भारत सरकार – रेल मंत्रालय
अनुसंधान अभिकल्प और मानक संगठन
लखनऊ & 226011
Government of India - Ministry of
Railways
**Research, Designs & Standards
Organization, LUCKNOW - 226011**

TECHNICAL CIRCULAR No. ELRS/TC/0076, Rev. 2

**OIL LEAKAGE FROM THE TRANSFORMER BUSHINGS
AND COVERS IN 3-PHASE LOCOMOTIVES**

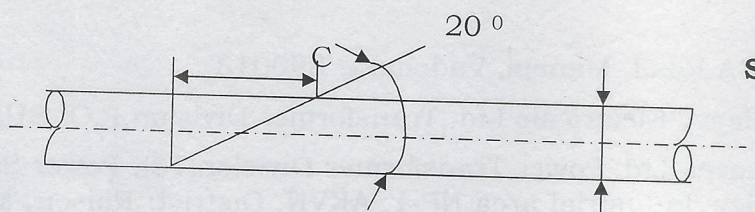
In order to prevent oil leakage from transformer cover gaskets as well as from the two bushing plate gaskets, it is necessary to use joint less gaskets as per details given in Table-4 below :-

In case of use of open ended gasket (generally, it should not be permitted), the procedure to be followed for vulcanizing the overlap joint I is as under :-

Cut the gasket ends at an angle of 20°. Apply rubber adhesives on both the cut edges and press it in a template. Heat the template at 155 deg.C for about 21 min. (Max. 26 min.) for gasket of dia. 16mm and for about 12 min. (Max.17 min.) for gasket of dia 7.0 mm.

REF. NO.	PART NO.	DESCRIPTION	DETAIL Dwg. NO.	NO.	DATE	SPEC
PEP-			SCALE:-	APPROVED BY:-		
LOCATION OF GASKET ON BUSHING ASSEMBLY OF LOT 6500/7500KVA TRANSFORMER				FIRST ISSUE		
RDSO ELEC DTE, SKEL-4663				SUPERSEDED

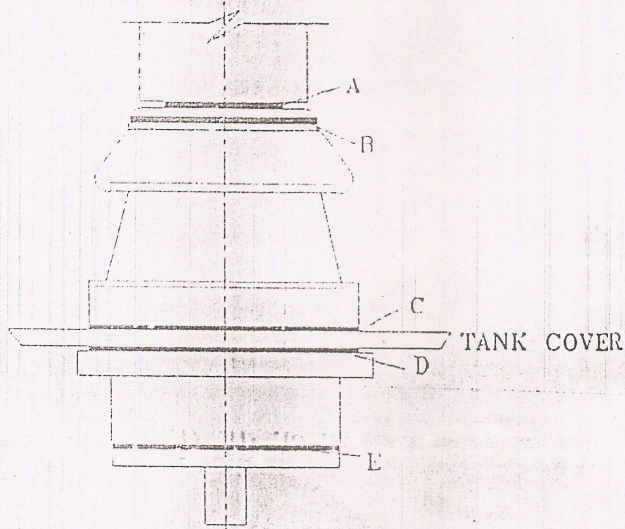
- 1.4 On the subject issue, RDSO has interacted with ABB and M/s ABB Secheron, the OEM of these transformers who have conducted a quality audit of their unit at Vadodara. Based on their global experience, ABB Secheron have recommended the use of NBR(Nitrile) gaskets at location B & C (SKEL-4663, Alt.1) in place of NEBAR gaskets. RDSO, has further discussed the matter with all the transformer manufacturers including ABB and it has been considered to use NBR(Nitrile) gasket for bushing gaskets at location 'B' and HNBR gasket for bushing gaskets at location 'C' with high temperature withstand capacity in place of existing NEBAR gaskets. Accordingly, the requisite changes have been incorporated in this Technical Circular.

STATUS	REF. NO.	DESCRIPTION	APP. BY	DATE
1	ABB'S AUDIT REPORT DT. 22.10.11	MATERIAL OF GASKET 'B' CHANGED FROM NEBAR TO NITRILE AND MATERIAL OF GASKET 'C' CHANGED FROM NEBAR TO HNBR	<i>[Signature]</i>	12/2/13

The Locations **A,B,C,D & E** of the gaskets are indicated in the RDSO drawing **SKEL No.4663, Alt.1** (Enclosed)

LOCATION	GASKET MATERIAL
A	NITRILE
B	NITRILE
C	HNBR
D	NBC
E	NBC
